AGENDA
DESIGN COMMISSION
Community Room, 3rd Floor
Arlington Heights Village Hall, 33 S. Arlington Heights Rd.
Arlington Heights, IL 60005
August 26, 2025
6:30 PM

Item: 502 E. Haven St. - SF/New - DC25-057

STAFF DESIGN COMMISSION REPORT

Project Name: Helashvili Residence
Project Address: 502 E. Haven St.
Prepared By: Steve Hautzinger
Date Prepared: August 21, 2025

02 EAST (RIGHT SIDE) ELEVATION
SCALE: 1/4"=1'-0"

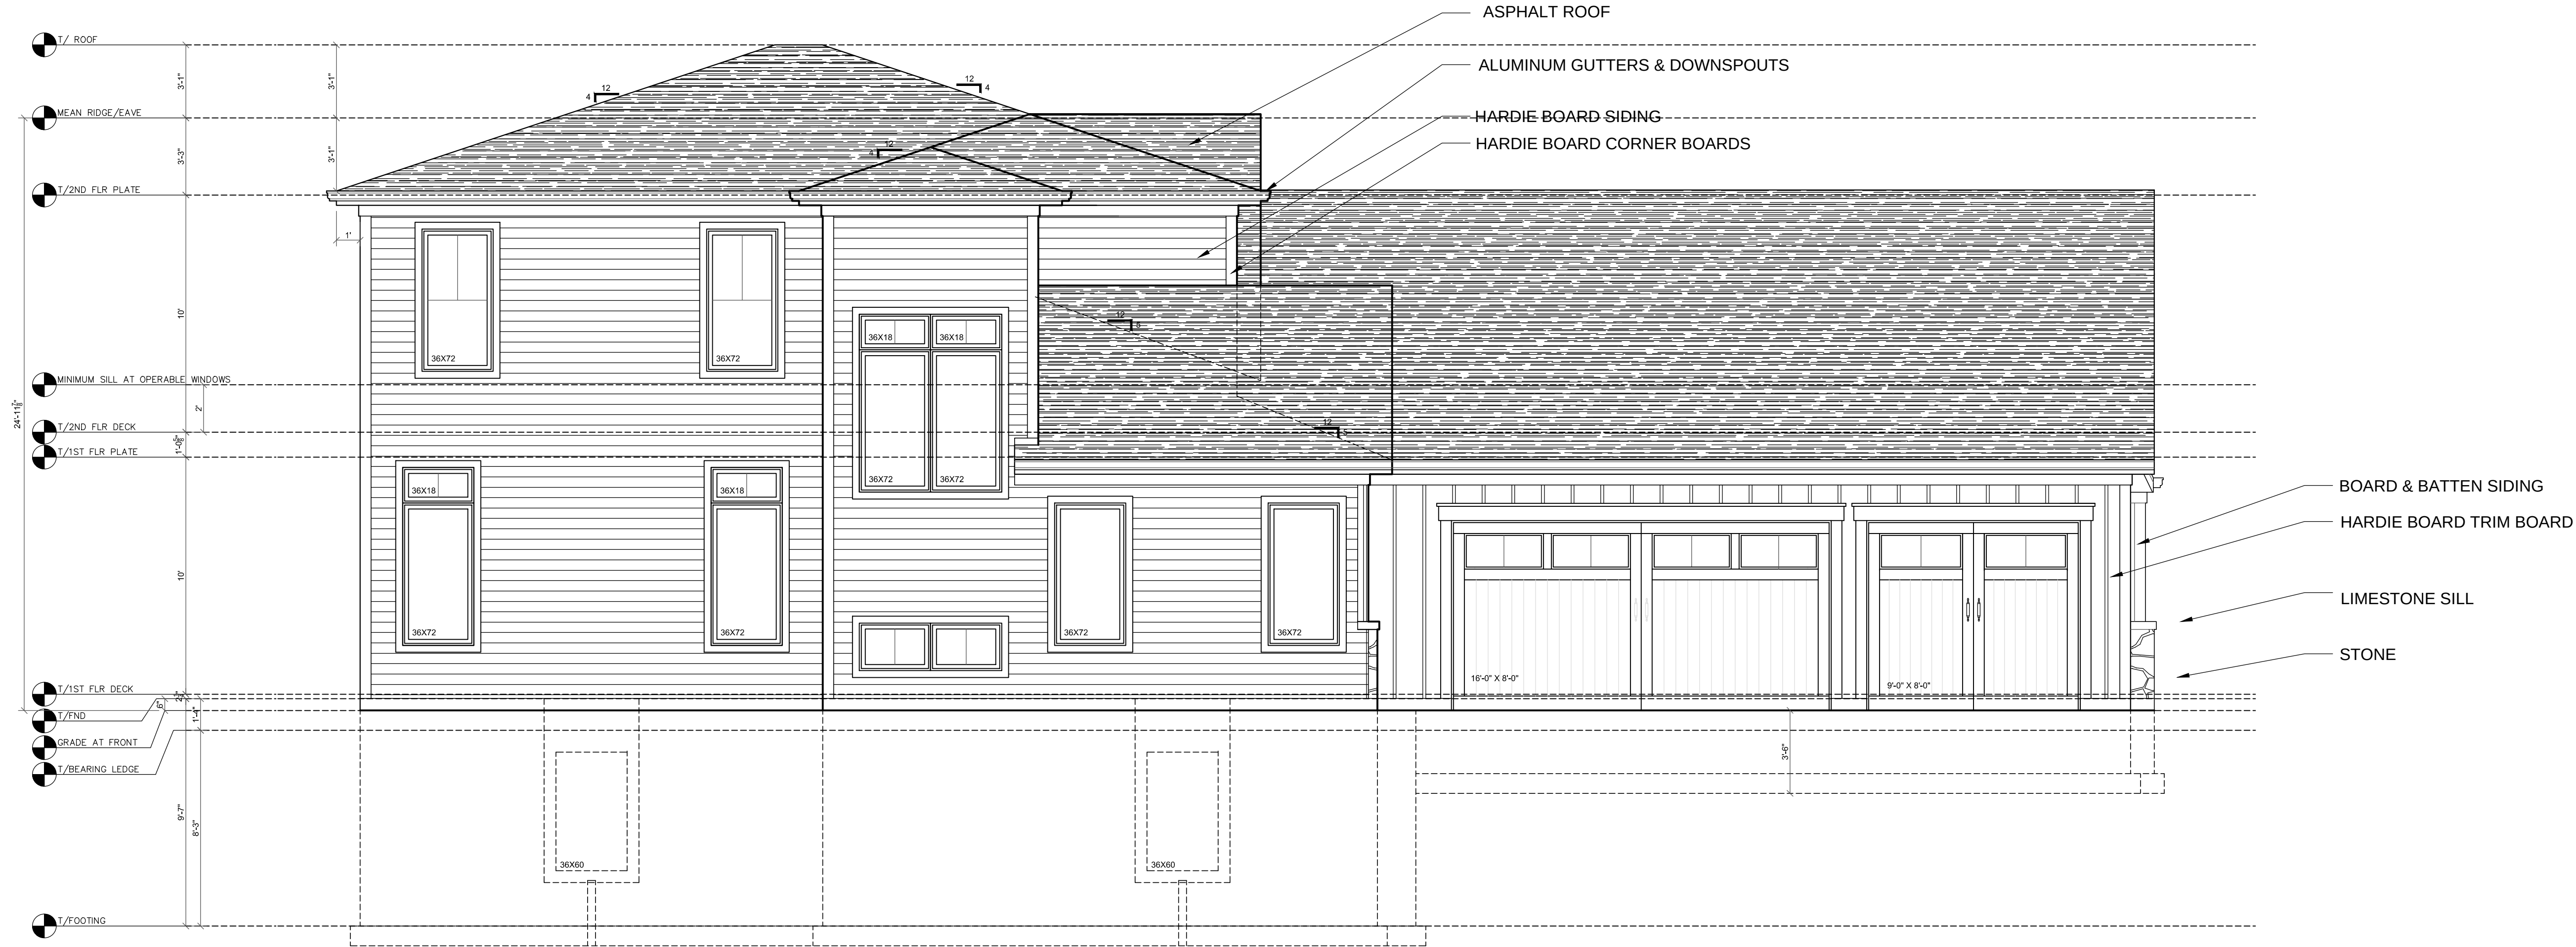
1. Evaluate the proposed all-siding black & white exterior against the surrounding context of primarily earth-tone masonry homes.
2. Evaluate the proposed three-car side load garage which pushes the main body of the house deep on the lot to the 30-foot rear setback.

1 EAST ELEVATION

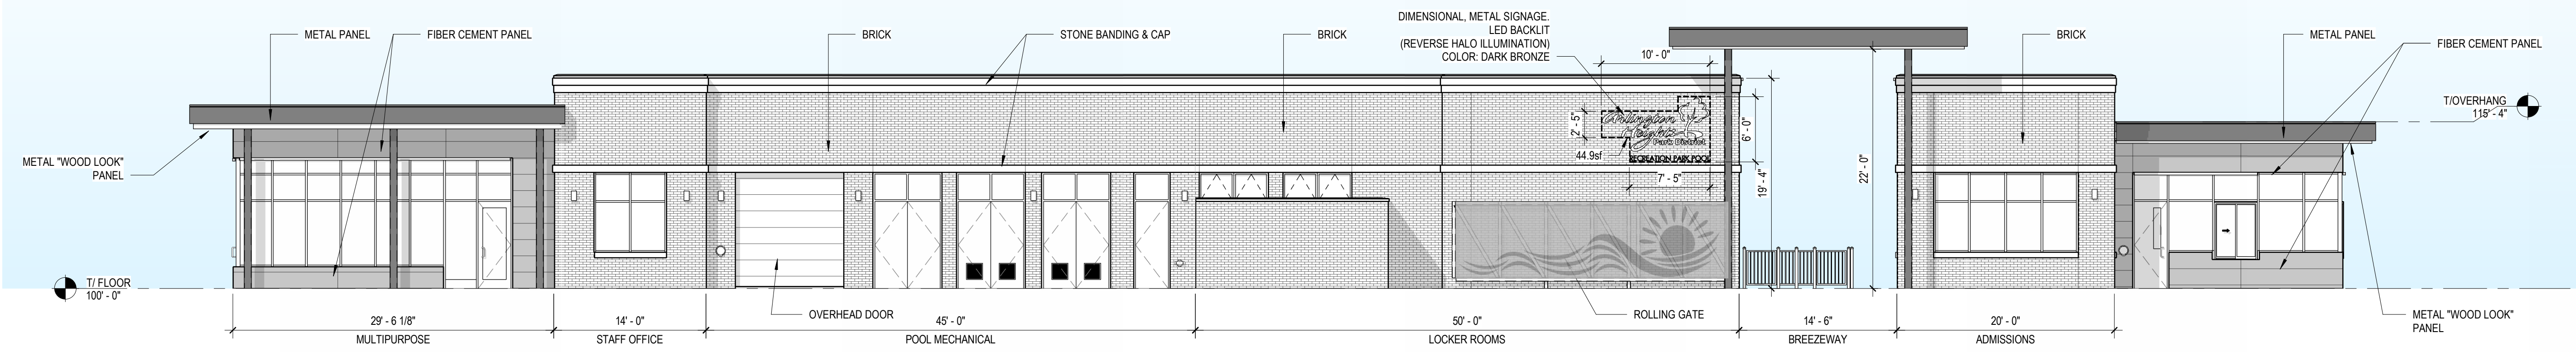
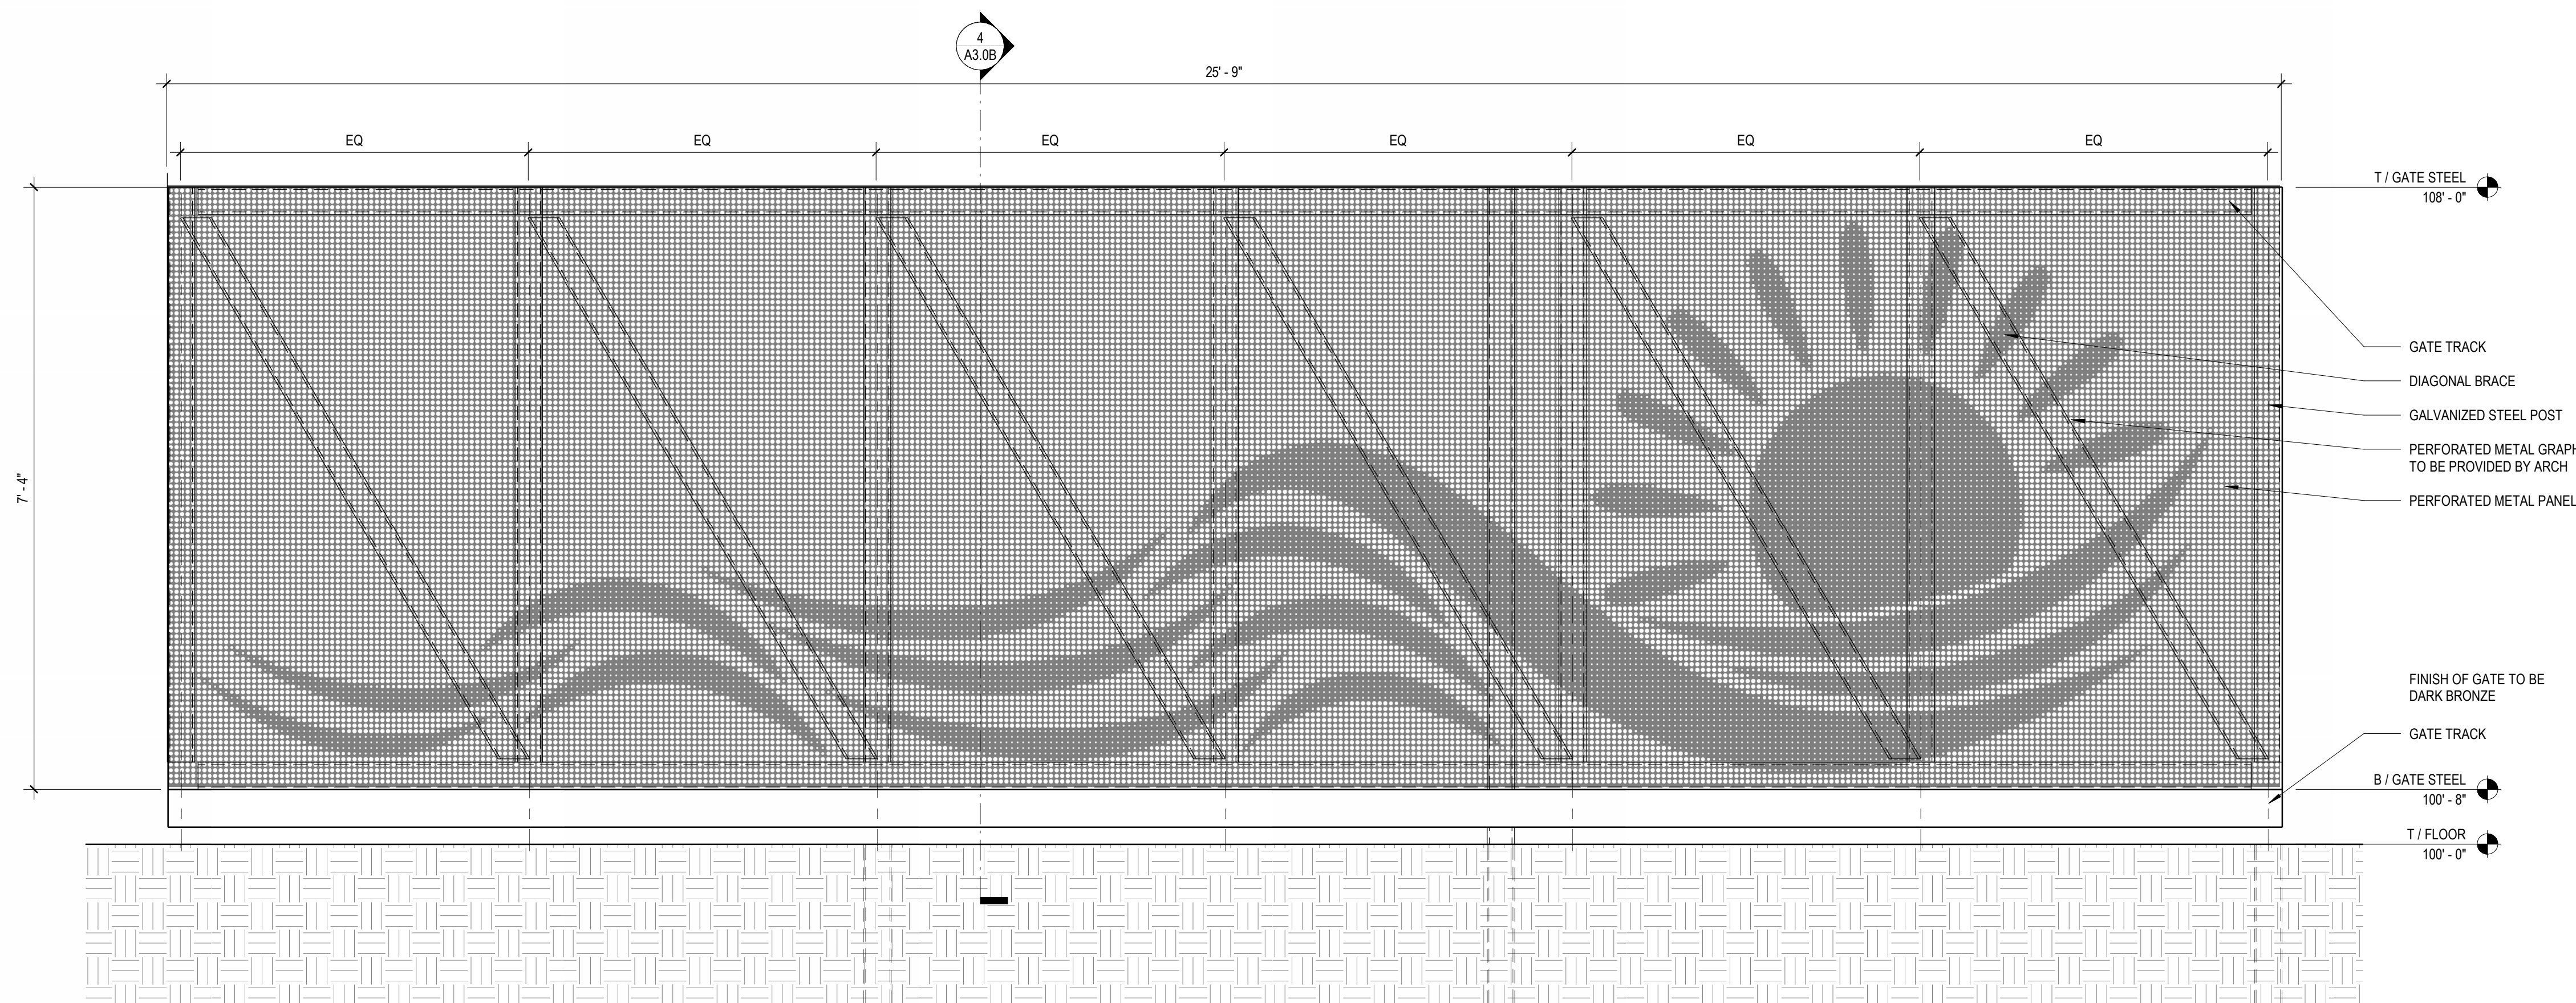
THIS APPLICATION REQUESTS A SIGN VARIATION FOR A ROLLING GATE ELEMENT AT THE BATHHOUSE THAT FEATURES AN IMAGE/GRAPHIC.

AS THIS GATE WILL BE A FEATURE VISIBLE AT ALL TIMES OF THE YEAR, THE PARK DISTRICT DESIRED TO INCLUDE A FUN, SUNNY IMAGE ON THE GATE IN ORDER TO REMIND PASSERSBY OF SUNSHINE AND POOL FUN, EVEN DURING THE DEAD OF WINTER. BY USING A METAL PANEL WITH PERFORATIONS, THE FUN GRAPHIC IS ACHIEVED WITHOUT USING BRIGHT COLORS OR REFLECTIVE MATERIALS THAT COULD BE CONSIDERED A DISTRACTION OR IN CONFLICT WITH THE BUILDING DESIGN.
